STEREO IMPACT SEP LVPS MIDDLE BOARD		2/26/2004
Requesting Engineer:	Approved by:	···
Date:	Date:	
Date.	Date.

STEREO IMPACT SEP LVPS FM1 MIDDLE BOARD REPAIR INSTRUCTIONS

1. U26 Pin6 connected to +5V (PFR-1004)

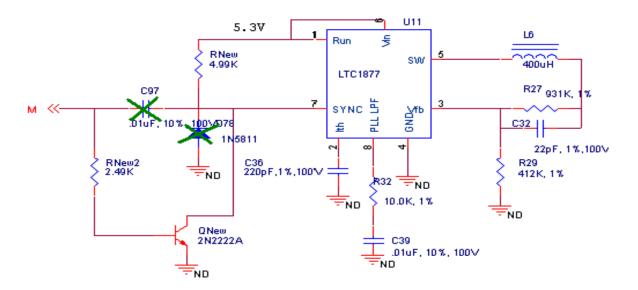
U26 pin6 (CEXT) must be only connected to 390pF capacitor (C83). The line connected was named +5V on the schematic. Therefore the layout generating software has connected the line to +5V. C83 must be removed and a new capacitor (CK05) must be installed. The value of the capacitor remains the same.

2.1 D78 and U11 repair Instructions

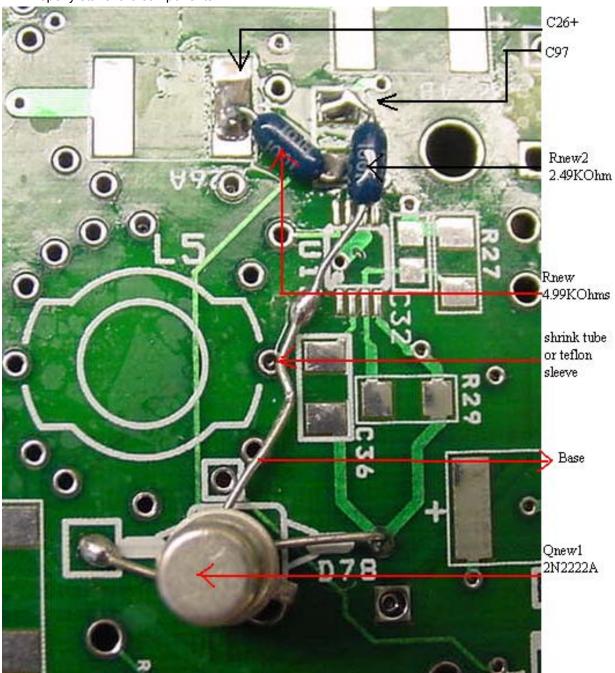
LTC1877 Sync signal (Pin 7) should not receive negative voltages. In order to prevent negative voltages at SYNC node, a transistor will be installed instead of a Schottky Barrier diode (D78 and D80).

Remove C97

Remove D78

Install 2N2222A Pin 1 to ground (anode pad of D78).

Install 2N2222A pin 3 to D78 cathode location.

• Connect a 2.49K Ω (RNew2) resistor to the base of 2N2222A transistor. RNC50H2491DS

• Connect other side of the 2.49K Ω to C97 where it connects to signal M.

Connect a 4.99KΩ (Rnew) resistor from C97 (SYNC side) to C26 + side which corresponds to 5.3V.

Use shrink tube or Teflon sleeves to cover any exposed leads.
